## Cover Letter

### Difference between WMI2-W167 to WMI2-W167-M1 & WMI2-W167-M2

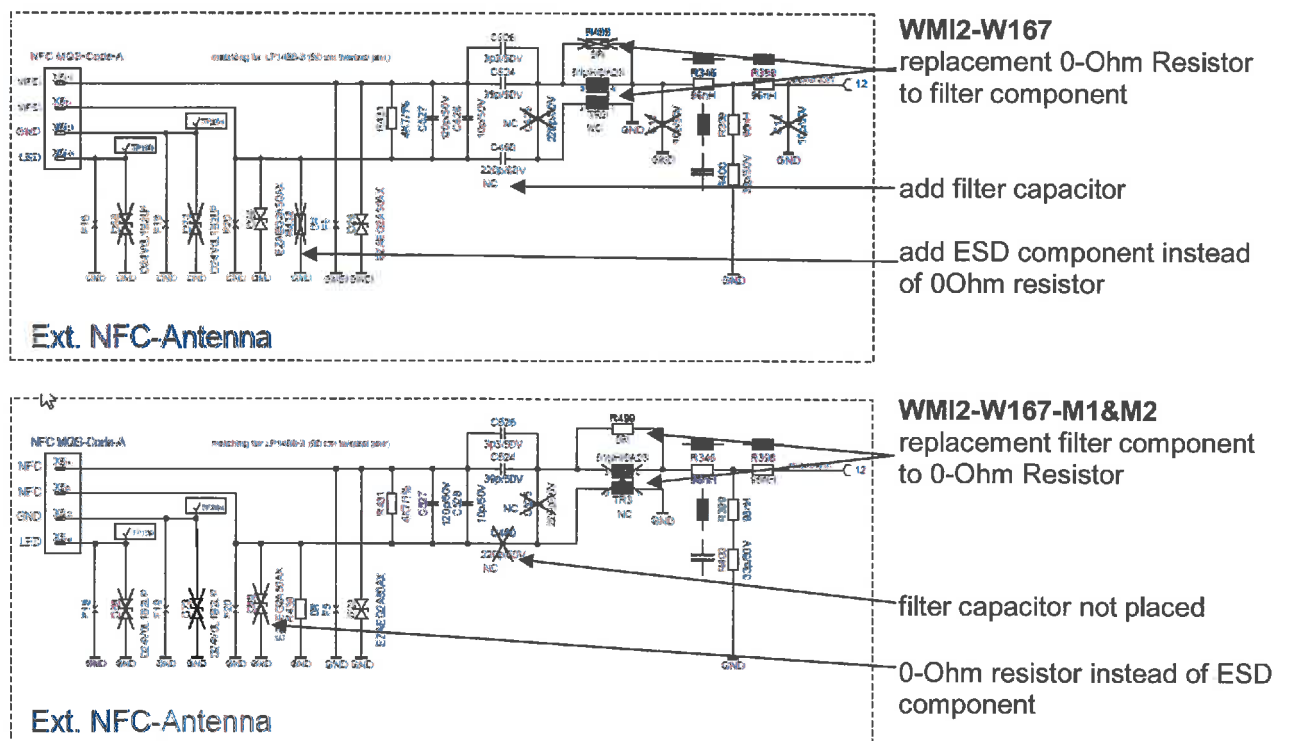
The 4-pole-MQS connector is basically interface for the external NFC antenna; the WMI2-W167 is very much the same to WMI2-W167-M1& WMI2-W167-M2 except the interface to external NFC Antenna.

The interface has been adapted to improve EMC stability.

The difference in the hardware on the main board is documented with enclosed pictures. It shows the schematics difference. This change also causes a layout change in this area. All other functions and placements are identical.
